CASE # C15-2014-0092
11158759

CITY OF AUSTIN
APPLICATION TO BOARD OF ADJUSTMENT
GENERAL VARIANCE/PARKING VARIANCE

STREET ADDRESS: 1302 Lorrain St.

MURCHISON ADDITION & REMODEL
 1302 LORRAIN STREET, AUSTIN, TX 78703

1 SITE PLAN

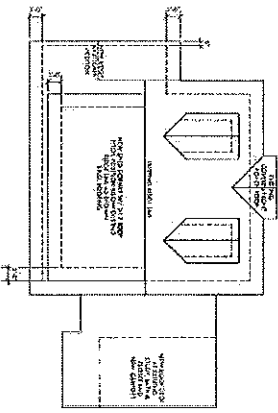
Hi Leane – I really appreciate your diligence and willingness to help us through this process. After looking at the site plan and looking at the draft letter, I have the following questions:

Re: rear setback. Aren't we just requesting that the rear setback be reduced from 10' to 7' – the rear wall of the existing house, which we want to improve by adding new framing to allow for a sliding egress door. We have already remediated existing building within 1.5' of the property line by removing it, and a wood deck that went all the way to the rear line.

If the stoop is allowed to project 3' into the yard, the proposed 4' stoop would reduce the setback an additional foot, to 6'. We could reduce the width of the stoop to 3' if necessary.

Re: front setback. Juan had commented on the front stoop, which originally had a different shape. The existing stoop extended 7' from the house, or 4' past the porch cover, before the steps started. The proposed front stoop now extends 6' from the house, or three feet from the covered part of the porch, before the steps begin.

3 1st FLOOR DEMOLITION PLAN

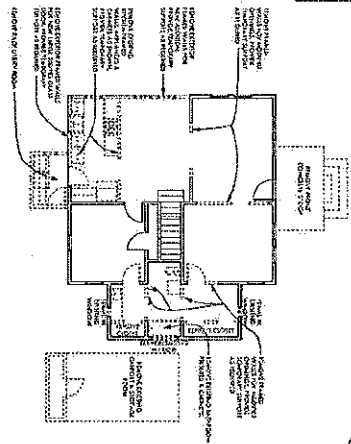
1. A copy of the approved Certificate of Appropriateness is required prior to approval. Please contact Steve Sadowsky at 512-974-6454 or steve.sadowsky@austintexas.gov.
2. The residence is over 40 years; partial demolition application has to be review by Historic Dept. Application has been sent to Historic Dept. for review. No action required at this time.
3. Concrete stoops must comply with LDC-2-513 (C).
4. For any project exceeding 20 feet in height or adding square footage to the second floor within the Subchapter F boundaries, permit exhibits must be sealed, signed and dated by a Texas-registered architect or certified building designer.
5. Applicant must provide new second floor square footage on page 2 and page 3 of the application. Verify FAR calculations.
6. Removal/ demolition of non-complying structural elements at existing kitchen area not allowed per 25-2-963 (B).
